# Service Bulletin

Bulletin No.: 17-NA-221

**Subject:** Poor Engine Performance in Extremely Cold Weather Conditions for LE2 Engines, Charge Air Cooler Icing - Malfunction Indicator Lamp (MIL) Illuminated, DTC P0299, P0236, P2227, P00C7 Set

Brand:	Model:	Model Year:		VIN:		Engine:	Transmission:
		from	to	from	to		
Buick	Encore	2016	2019	SOP	September 18, 2017	Equipped with 1.4L (RPO LE2)

5197596

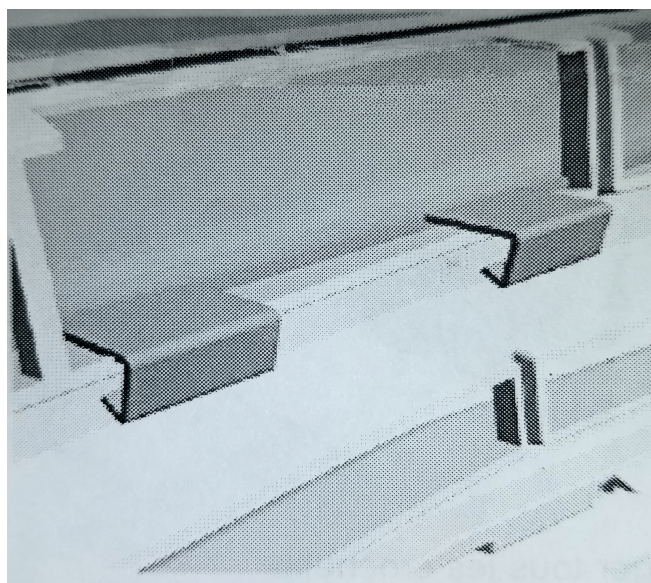
1. Using care, orientate the fascia winter cover to the bumper fascia.

4108751

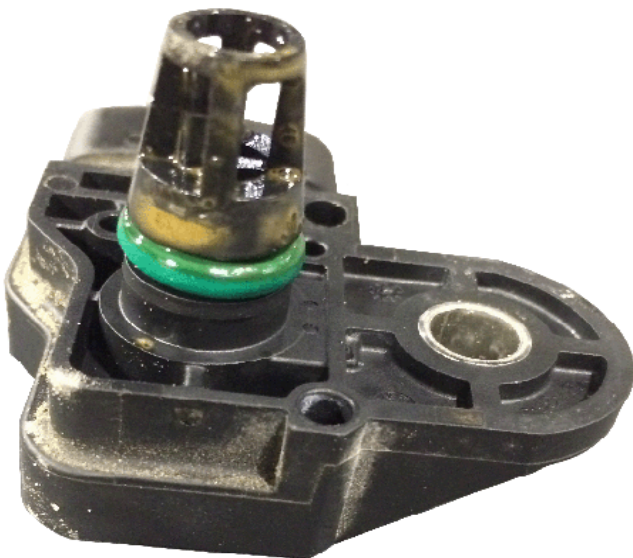
1. Remove the turbocharger Air Pressure sensor (3). Refer to *Turbocharger Air Pressure Sensor Replacement* in SI.

5020216

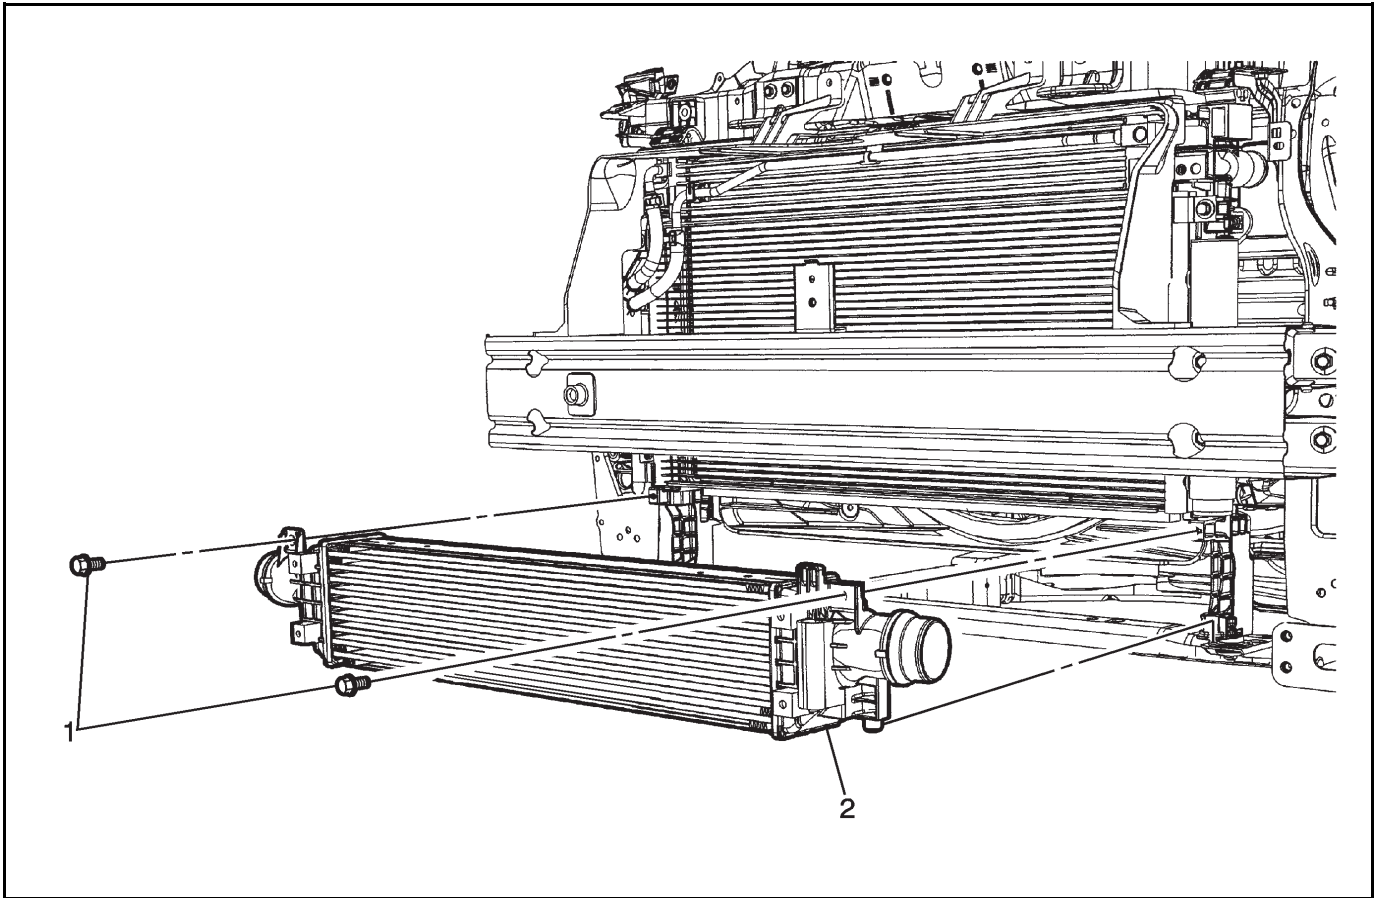
**Important:** Due to the sensitivity of the sensor, **Do Not** use any chemical cleaners including water and **Do Not** use compressed air to remove contaminants.

2. Inspect the sensor for any contaminants.

3. Allow time for any ice build-up to melt by placing the sensor port down.
4. Clean the sensor with a clean towel.
5. Install the sensor.
